Design Review Subcommittee (DRSC)

Meeting Date: June 9, 2016

SUBJECT: Amendment to Site Plan Permit 98-63, Reserve Landscaping a request to modify the approved landscape plan for the Reserve community in the Residential Low (RL) zoning designation of the Forster Ranch Specific Plan. The project site is located at the corner of Avenida Vista Hermosa and Avenida Vera Cruz.

EXHIBIT "Y"

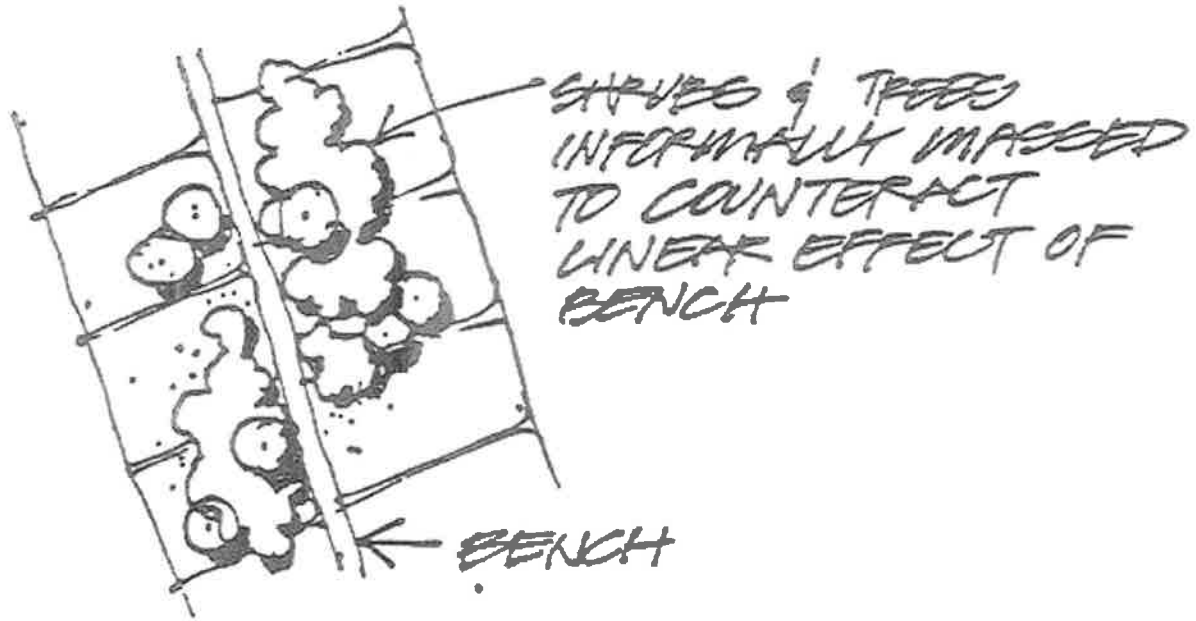
The approved plan complied with the HDO standards by placing taller trees at the top of the slope parallel to the houses' side property lines, to screen the development from public views and still provide an ocean view corridor for the property owners. Design examples are shown in HDO Exhibits A, G, X, Z, AA and BB that are similar to the approved landscape plan approved for the Reserve. These exhibits provide requirements for hillside developers to make projects visually pleasing and blend them in with the natural environment.

The intent is to create the arrangement of informal masses of landscaping to selectively allow views from housing while partially screening buildings and reducing the scale of overpowering, long, steep slopes.
